August 23, 2020

Re: Final Environmental Impact Statement, No. 20200148
Pebble Mine, AL

This technical memorandum provides a review of responses to issues raised in Requests for Information (RFIs) 008g and 008h, “Followup to Seismic Stability Analysis,” regarding tailings liquefaction potential and stability of the centerline portion of the bulk tailings storage facility (TSF) main embankment. The responses to these RFIs were provided in Pebble Limited Partnership (PLP) 2019-RFI 008g, Knight Piésold (KP) (2019), and PLP 2019-RFI 008h. The response to RFI 008h is provided in Attachment A to this memorandum for reference.

Figure 1 – Deterministic Response Spectra for TSF Maximum Design Earthquake Scenarios

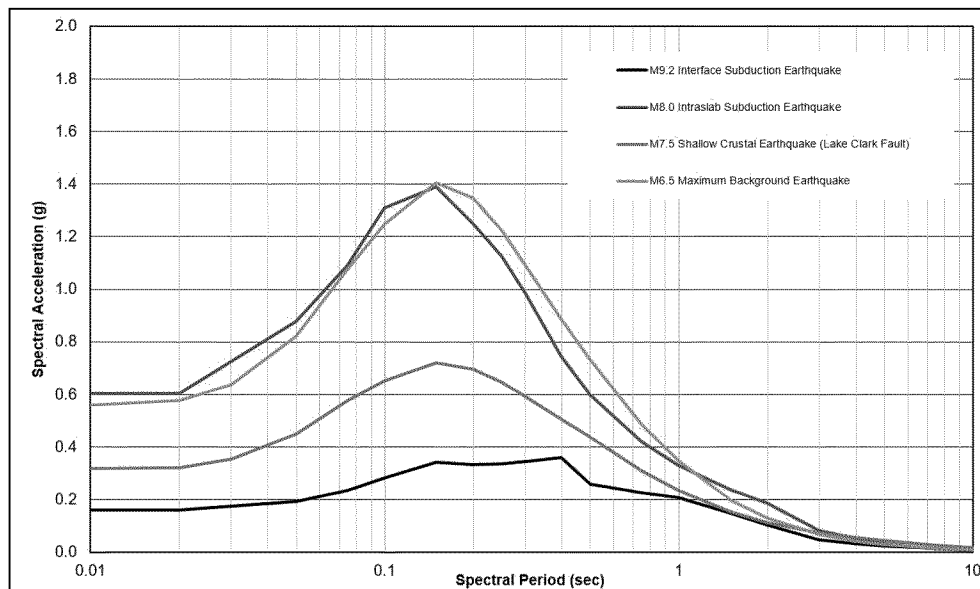
- b. The response spectra KP (2019a) computed for the subduction scenario earthquakes only extend to 2 seconds. The Atkinson and Boore (2003) and Zhao et al. (2006) equations extend to 3- and 5-second periods, respectively. Please provide the response spectra computed to 10 seconds by noting the applicable period bands for each equation and re-weighting the remaining equations when one is no longer applicable.**

The deterministic response spectra provided on Figure 4.1 and in Table 4.2 of KP 2019a have been revised to include spectral acceleration values up to 10 seconds as shown in Figure 1 and Table 1 below. The spectral accelerations for periods from 3.0 to 5.0 seconds have been calculated using average values (equal weighting) using the ground motion prediction equations of Zhao et al (2006) and Abrahamson and Addo (2016). Spectral accelerations for periods of 7.5 and 10.0 seconds have been calculated using only Abrahamson and Addo (2016).

Figure 2 - Upstream Stability – Post Liquefaction – Full Depth

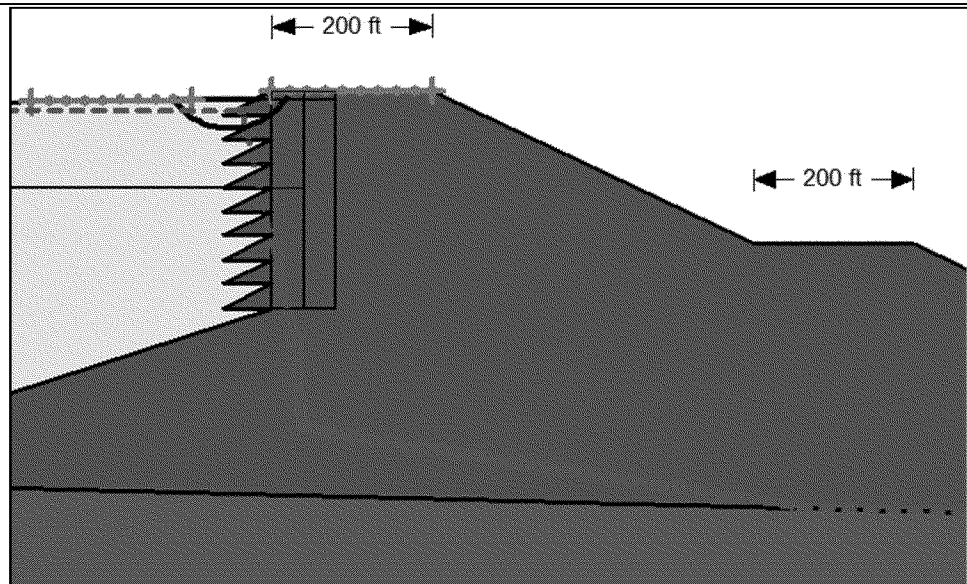
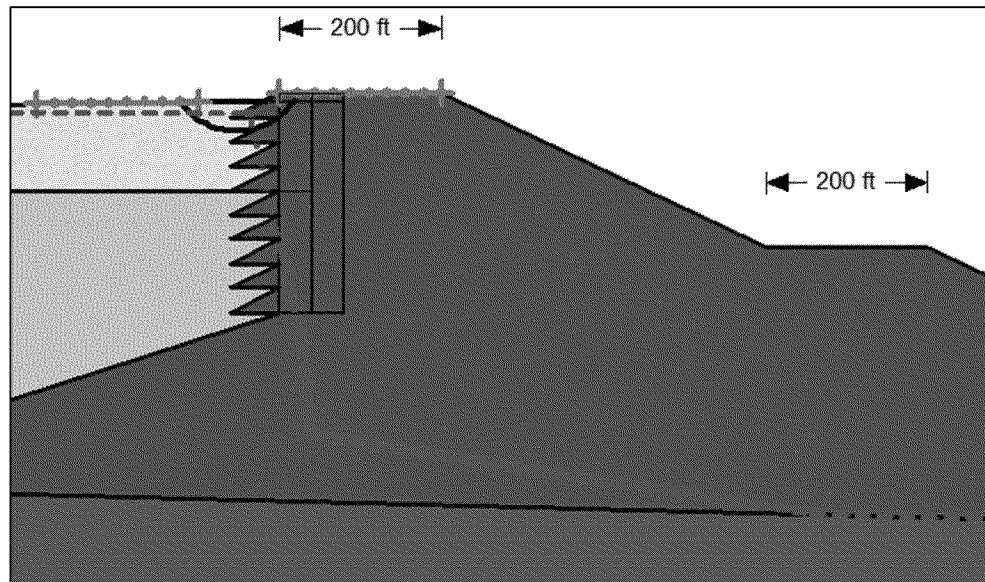
Considering that the upstream part of the centerline raises are planned to be built partly over tailings, it is unclear if the post-liquefaction shallow failure surface shown in RFI 008h Figures 2

and 3 is constrained by the analysis to include only the uppermost centerline raise based on an assumption that the tailings would buttress any failure surface deeper than the top raise. We are concerned that the analysis does not allow for a deeper failure surface to occur up to the depth of the lowest centerline raise. Because the response to Item #7d regarding risk reduction in the event of tailings liquefaction only pertains to the upstream case, we are also concerned that more of the centerline part of the embankment below just the most recent raise could slide into potentially undrained tailings, setting the mass in motion with adverse consequential effects on the TSF in a downstream direction.

In addition, as with the tailings liquefaction results described in Section 2.4 (RFI 008h Figures 2 and 4), the results for the high phreatic surface in the bulk TSF main embankment are provided for a post-liquefaction case only, but not for a case during the period of strong ground shaking.

A potential slip surface for the fully liquified case is shown on Figure 2. A slip surface with a FoS of 1.2 is shown, as per the minimum acceptance criteria. The results illustrated on Figure 2 indicate that the Zone U material placed on tailings beach deposits will likely undergo settlement, however, the deformations are likely to be constrained to the upstream zone of the embankment. These results are similar to the previous scenarios (KP, 2019b) where only 100 ft of tailings liquefaction was considered, as presented on Figure 3.

Figure 4 – Downstream Static Stability – Post Liquefaction

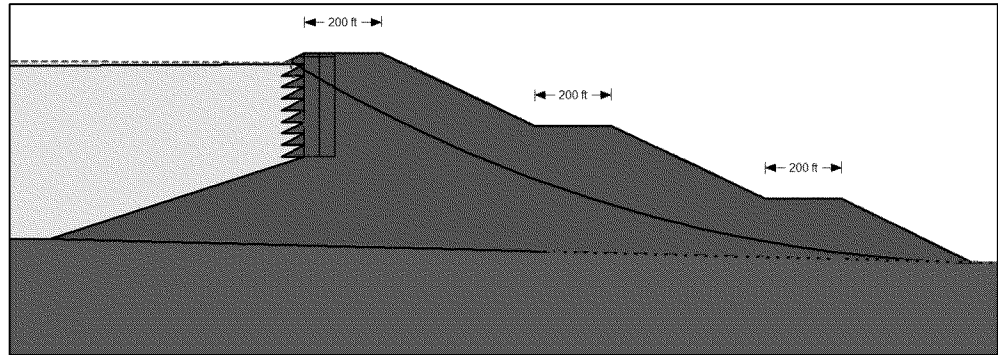
The fully liquefied, post-liquefaction case in a downstream direction shown in RFI 008h Figure 4 is based on an assumption of a deep phreatic surface with no excess pore pressures in the TSF main embankment (i.e., $ru = 0$). While a scenario with a higher phreatic surface is analyzed under Item #9c of RFI 008h (Section 2.7), the yield acceleration (ky) values in Table 3 can be considered practical upper bounds only (e.g., arguably too high, not conservative enough), and the reported factor of safety (FoS) and ky /peak ground acceleration (PGA) values in Table 3 considered conditional calculated values only, subject to the validity of the assumptions.

Downstream static stability analysis considering fully liquified tailings (shear strength of 0.05) are present in Figure 4 below, with a resulting FoS above 1.8. The liquefaction of the tailings does not affect the downstream stability of the embankment.

Figure 5 - Downstream Stability – Post Liquefaction, Higher Phreatic Surface

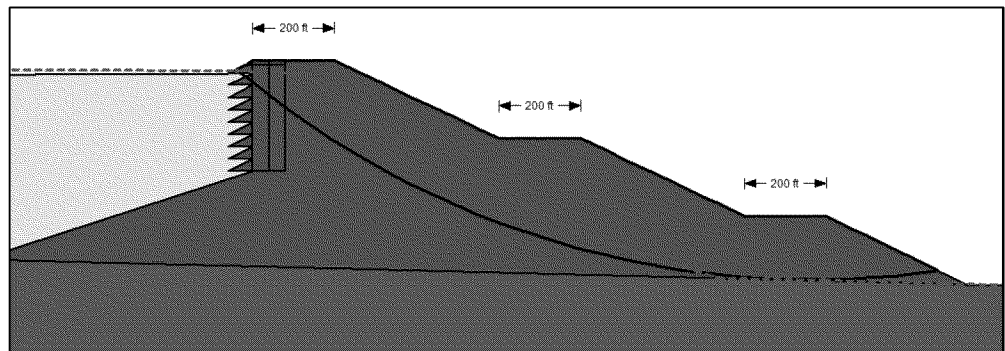
The response to Item #9c in RFI 008h (Figure 5) presents the results of a post-liquefaction, static stability analysis of the bulk TSF main embankment in the downstream direction assuming a

higher phreatic surface than that used in Figure 4. However, the assumed phreatic surface could be even higher if clogging occurs in the embankment, potentially seeping out of the buttress face. Also, no pore pressures are assumed (i.e., $ru = 0$), which is not reasonable for an earthquake with a long duration of strong ground shaking. Thus, the calculated FoS and associated δy or deformations are conditional on relatively optimistic assumptions, which overstate embankment stability and underestimate risk if the planned embankment flow-through functionality does not perform as assumed.

The downstream static stability of the post-liquefaction condition (tailings shear strength of 0.05) was assessed using a revised phreatic surface, which is considerably higher than that applied for normal operating conditions, as shown on Figure 5. This model assumes the phreatic surface remains just below the crest of the embankment for half the width of the embankment crest. This modelled scenario assumes the filter and transition zones are fully blocked and act similar to a core zone within the embankment, with the downstream rockfill shell providing drainage capacity. This scenario is highly unlikely considering the typical characteristics of rockfill material.

The resulting FoS with the higher phreatic surface is in the range of 1.8 to 2, slightly lower than the previous static stability results. The stability analysis will be updated on an ongoing basis as the preliminary and detailed design phases of the ADSP are advanced.
